## TECHNICAL SERVICE BULLETIN

### Torque-On-Demand (TOD) Transfer Case - Grinding/Clicking/Ratcheting Noise From Front Wheel Area

**20-2307**15 October  
2020**Model:**

<b>Ford</b> 2003-2020 Expedition
2006-2020 F-150
<b>Lincoln</b> 2003-2020 Navigator

Figure 2

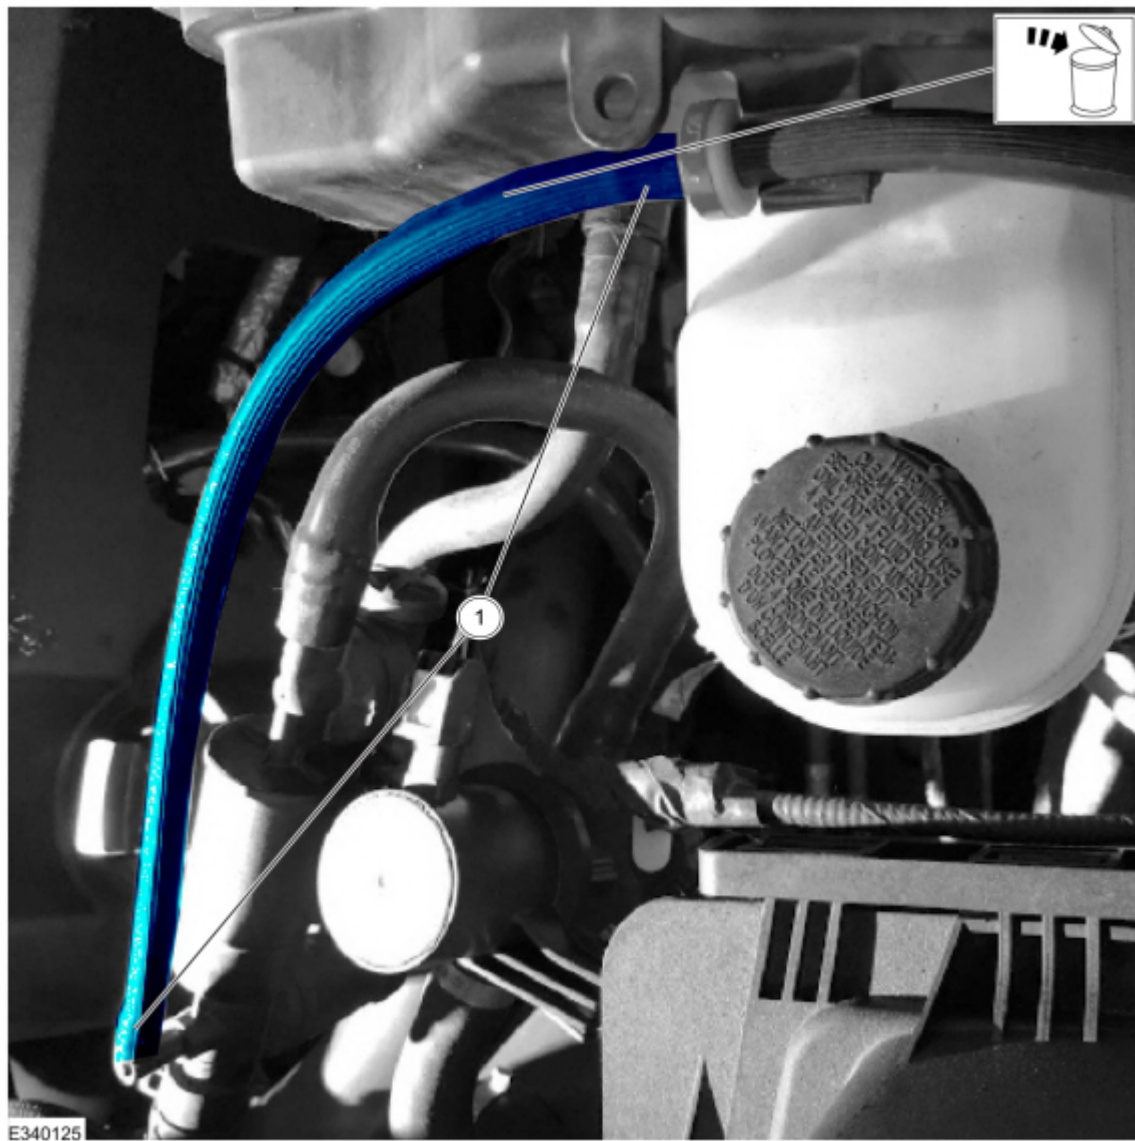
2. Locate the vacuum supply line between the source vacuum and the IWE check valve. Refer to WSM, Section 308-07A. (Figures 2-3)

**3.** Remove the vacuum supply line.

**4.** Install the vacuum caps at the IWE check valve and the vacuum source.
